### **IMPORTANT NOTICE – RECALL**

#### **Replacement of Cap for Valve Body Assy**

Yamada Corporation has determined that a defect may exist in some of our Air Operated Diaphragm Pump NDP-P20/20-PP and P25/25-PP series.

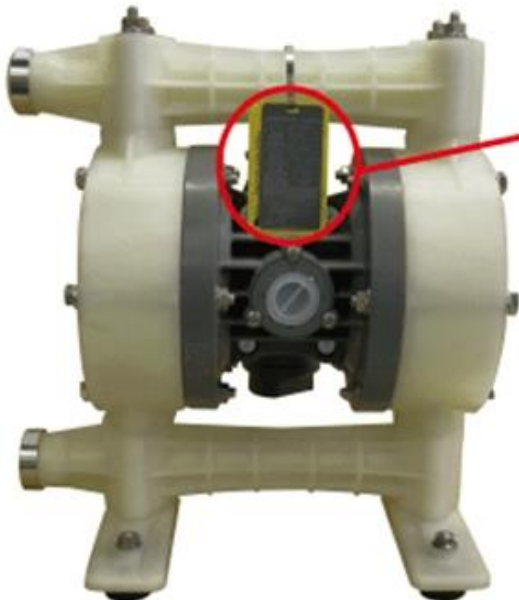
Cap A (part number 772946) and Cap B (part number 772947) are located at the top and bottom of Valve Body Assy. The defect is that some of the plastic screw parts of Cap A and Cap B have shrunk and are smaller than the ones at the original molding stage. If the defective pumps are operating, the cap may come off from the valve body assy, and it might hurt human body in worst case.

We shall provide replacement parts free of charge.
